19 Thermostat, electric fault (DTC P0599, P0597, P2181)

19 15 63 2042328/1 October 29, 2015.

Model(s)	Year	VIN Range	Vehicle-Specific Equipment
S5	2008 - 2012	All	4.2 FSI
RS 5	2013 - 2015	All	4.2 FSI
A8	2011 - 2012	All	4.2 FSI

Technical Service Bulletin

Figure 2. Coolant thermostat housing for map-controlled engine cooling.

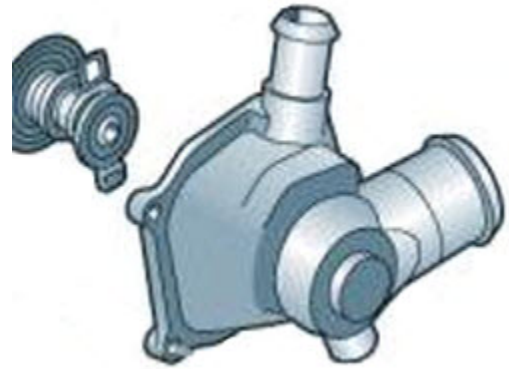
Tolerances of opening spring in thermostat cause the condition

If one of the DTCs listed in the *Condition* is stored, replace the coolant thermostat housing for map-controlled engine cooling (Figure 2).

Modified coolant thermostat housing.

It is not necessary to replace the complete coolant pump.
